ISSUE RESOLUTION STATUS REPORT

**KEY TECHNICAL ISSUE: REPOSITORY DESIGN AND
THERMAL-MECHANICAL EFFECTS**

**Division of Waste Management
Office of Nuclear Material Safety and Safeguards
U.S. Nuclear Regulatory Commission**

July 1999

Figure 16. Simulated rockfall after 100 years of thermal loading and one episode of dynamic ground motion for two slightly different fracture patterns

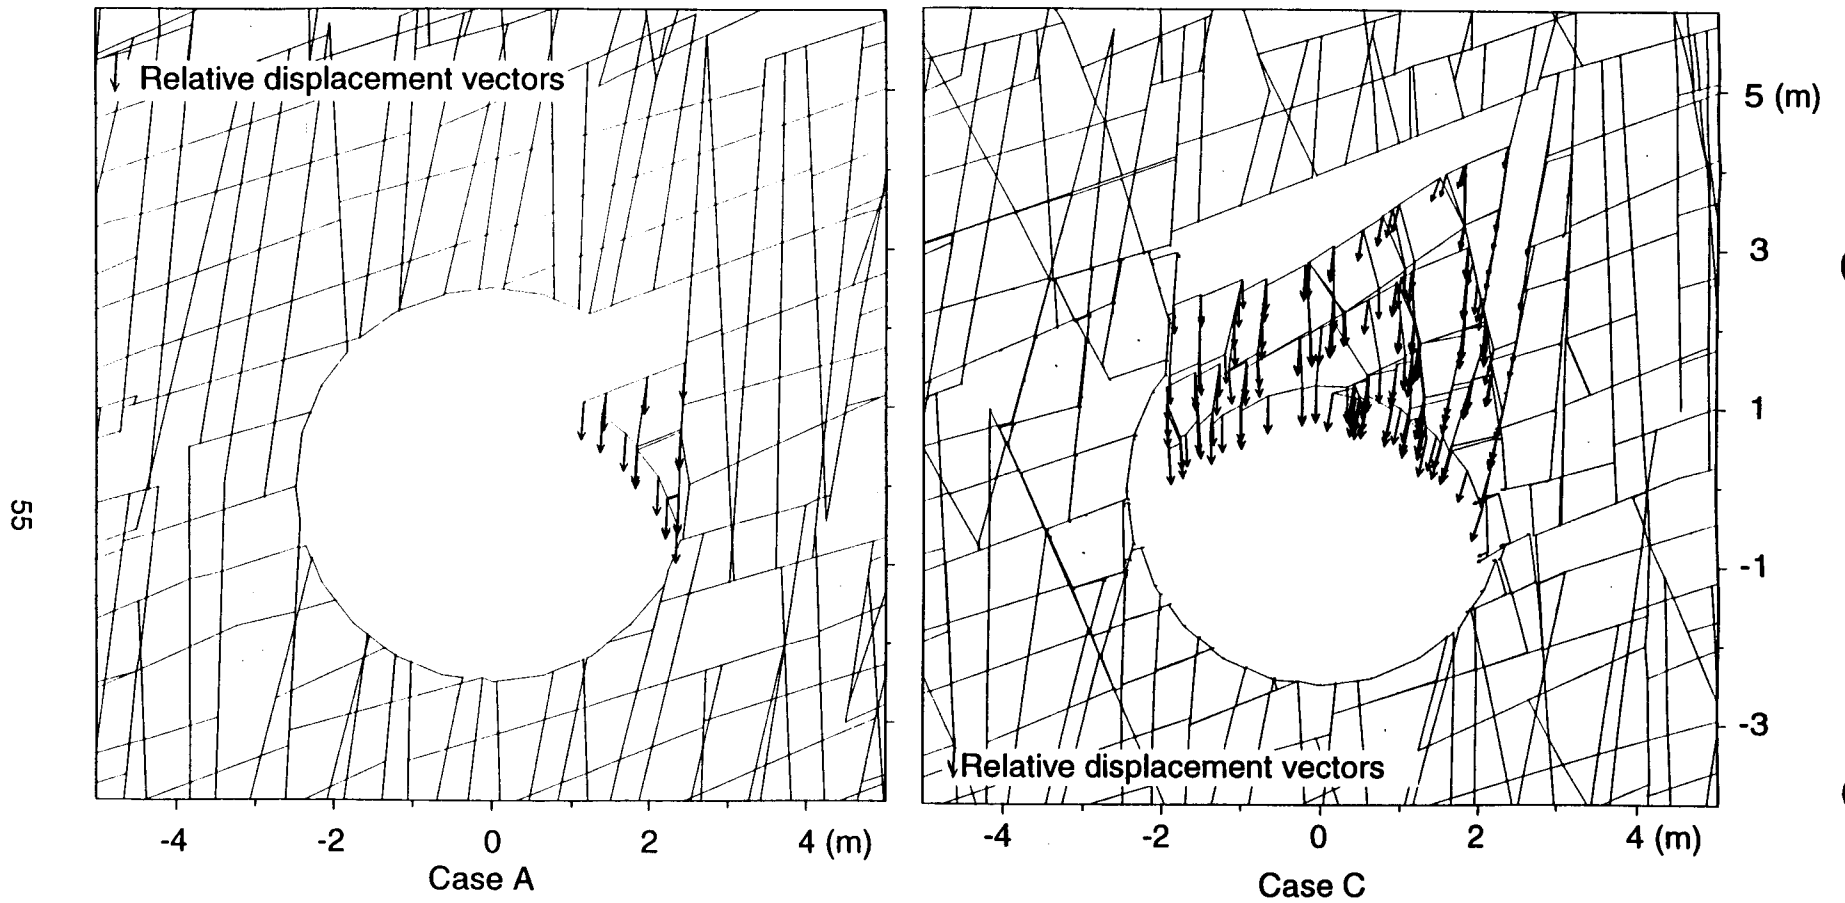
Dynamic modeling results show that of all these factors, fracture pattern may have the most significant effect on rockfall. Therefore, analyses using a regular fracture pattern such as the one shown in Figure 16 may not be conservative. An ongoing effort at CNWRA is to simulate fracture network patterns representative of the *in situ* conditions based on mapping and scanline data from the ESF and Cross Drift. Future dynamic analyses will incorporate more realistic fracture patterns and recent changes in DOE repository design.

Figure 19. Damage level versus peak ground velocity

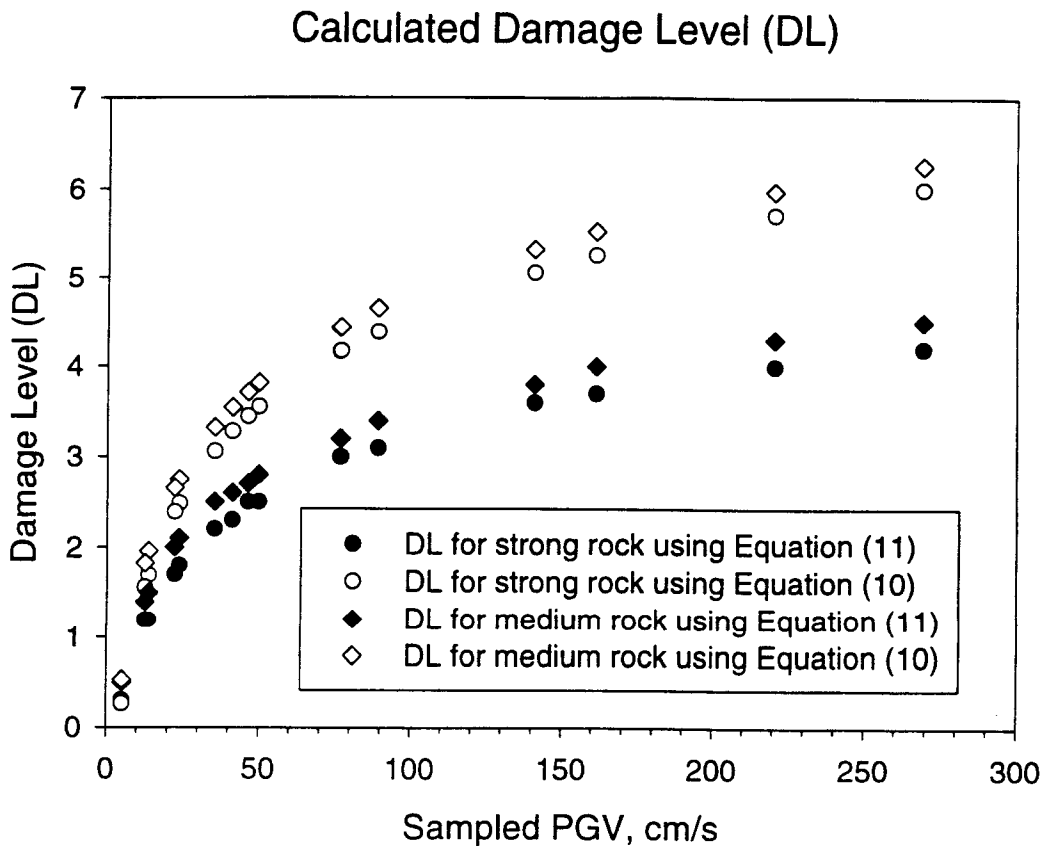
Figure 19 graphically shows the difference of *DL* values calculated for various peak ground velocity (*PGVs*) using these two equations. The calculated *DL* value is about 40 percent smaller for strong rock and about 30 percent smaller for the medium rock if Eq. (11) is used. It is not clear which equation was intended to be used in the TBD. If Eq. (11) is the correct equation, DOE needs to provide justification. If the use of Eq. (11) is a mistake, this mistake needs to be corrected and the rockfall effect on WP damage reevaluated.
